NWLTF is a consortium of Residents Associations (West Park, Weetwood, Drummond and Churchwood, Beckett Park, Far Headingley, and North Hyde Park) which, between them, represent much of the area under the flight paths to the south and east of the airport.

We are now contacting you with a further comment and complaint about the consultation process undertaken by LBA. Our previous more detailed comments and complaints still stand. This latest complaint has two components. Firstly regarding an apparent error in the LAm<sub>ax</sub> noise contours and secondly with regard to LBA's admission that some of its own consultation material was misleading.

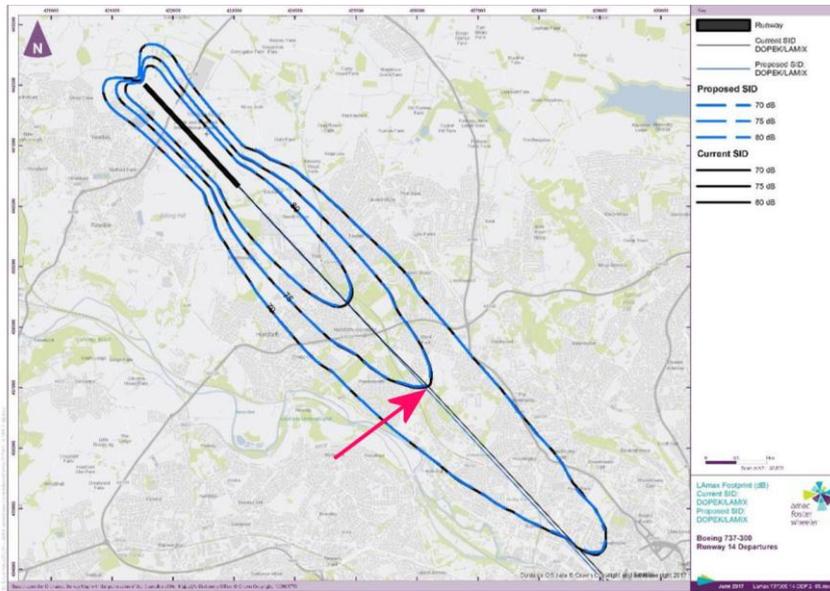
1. Respecting the LAm<sub>ax</sub> noise contours; we have noticed that the distance between the 75Db and 70Db contours (as shown in Figure 6.3 of the Consultation Addendum and reproduced below as Figure 1) is inconsistent with the airport's statements about the height at which aircraft are flying. We have been told (in a meeting on 13<sup>th</sup> February) that departing aircraft pass over the Beckett Park campus at between 3500 and 4500 feet (this is consistent with our own estimate based on assumed climbs at 15° for the first 1200 feet and at 10° thereafter and suggests that aircraft will be at about 3543 asl [c3200' above local ground level] when they pass over the point marked with an arrow on Figure 1 below). If this is correct, the 70 Db contour should be about 4700 feet from the 75Db contour at this point (based on geometry and the amounts of attenuation expected in 3200 feet and in 5685 feet). However, in Figure 6.3, the contours are shown as being only 2400 feet apart. We accept that our calculations will not be precise but the difference between 4700 and 2400 is too great to ignore.

Assuming our calculations are broadly correct, there are two possible reasons for the difference. EITHER the contours are incorrectly positioned – in which case the consultation material was very misleading in respect of the LAm<sub>ax</sub> contours and, by inference may have been be equally misleading about the other indices of noise, OR aircraft are at much lower altitudes at this point than we have been led to believe (2400' of separation between the 75 and 70 Db contours suggests an altitude of about 1700' algl [c2400' asl] ) which cannot be acceptable at a point about a mile beyond the end of the designated PNR.
